SUBJECT: 87-36-CUP

LOCATION: South side of Avenida del Diablo, between Valley Parkway and Del Dios Highway, addressed as 1817 Avenida del Diablo

REQUESTED ACTION: A modification to a previously approved Conditional Use Permit to add a 23 space parking lot and a 2,000+ SF expansion for rehabilitation facilities at an existing convalescent center in the R-1-10 zone.

SITE PLAN

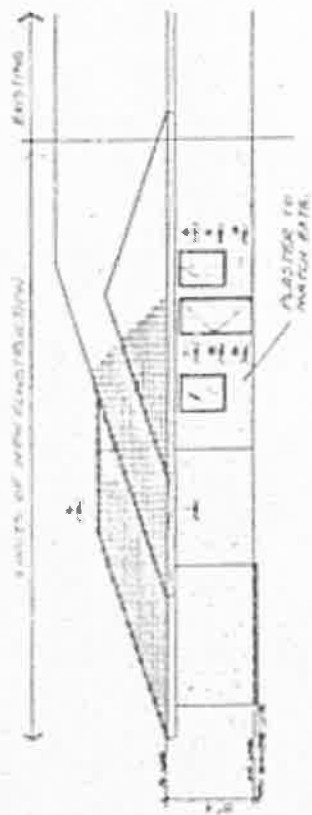
Building Addition -- The expansion will be located to the west of the hospital and will be screened from the east by existing buildings, and by a parkway wall to the north, south, and west. The proposed expansion will be compatible since the architecture, colors, and building height will match the existing structures; the extent of the expansion is minor; setbacks are observed; and adequate parking is provided.

New Parking Lot -- The new parking lot will provide another 23 standard size parking spaces which satisfy the additional parking required for the expansion and new staff as well as provides 10 extra spaces. This lot is conditioned to be used only by staff in order to make more guest spaces available in the northwestern lot. Although the two lots are not physically connected, they conform with code since neither lot has multiple aisles which require the use of the street to get from one to the other. The proposed parking lot will be compatible since it will be screened by existing buildings to the north, a parkway wall to the south and west, and a bermed 10' landscaped setback to the east.

2. A minimum total of 47 parking spaces shall be provided and shall be double striped per City Standards, with minimum dimensions of 18' x 8.5' (a 2' vehicle overhang is permitted). The existing parking lot shall be resurfaced and double striped to City Standards. A minimum of two handicap parking space are required and shall be striped to Title 24 standards, 18' x 9' with an adjacent 5' wide loading/unloading area. The vehicle turnaround areas shall be striped and marked for no parking.

3. The new southerly parking lot shall be designated for staff parking only and shall be identified as such in the field, to the satisfaction of the Planning Department. Appropriate signage shall also be provided which identifies the visitor and patient parking area in the existing lot to the west of the buildings.

6. Prior to commencement of construction, two sets of landscape and irrigation plans shall be submitted, which provide screening of the new parking lot from Del Dios Highway with a combination of berming and shrubs. Any existing vegetation to remain shall be identified, and the required trash enclosure and existing driveway to the storage building shall also be shown.
